## SITE VISIT REPORT NO. 1

<b>Project:</b>	<b>ST. ANDREW'S CHURCH</b> <b>75 SIMCOE STREET, TORONTO</b>	<b>File No.:</b>	J003-001
<b>Owner:</b>		<b>Site Visit Date:</b>	18-Sep-08
<b>Contractor:</b>		<b>Report Date:</b>	20-Sep-08

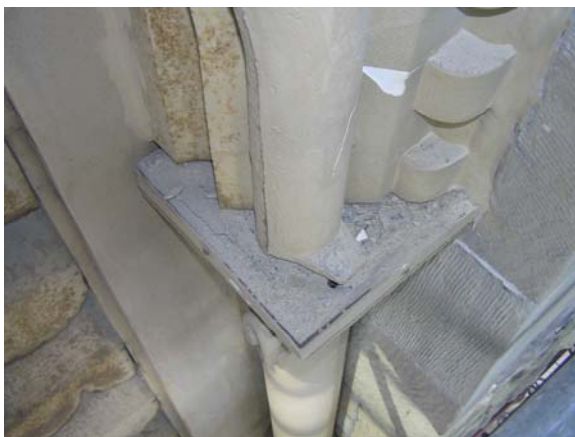
This and the following photograph show steel shim plates between the decorative cast iron elements and column capital plate. These shim plates are not original.

There was obviously some restoration of cast iron decorative arch structure in the past. The extent and quality of workmanship can not be assessed short of complete dismantling.

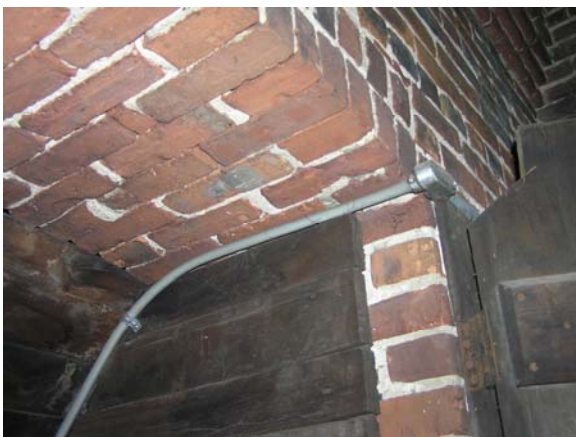
It is interesting to note that at several locations column base appears to be lifted from stone base. In this location, we were able to insert a sheet of 8 ½" x 11" cardboard (soft) as shown in photograph.

We are concerned that the columns are not positively attached to the stone base.

There seem to be some thin plates that could have been used to attach column to stone, but the gap between the two is evident.

We recommend further investigation of the whole assembly.
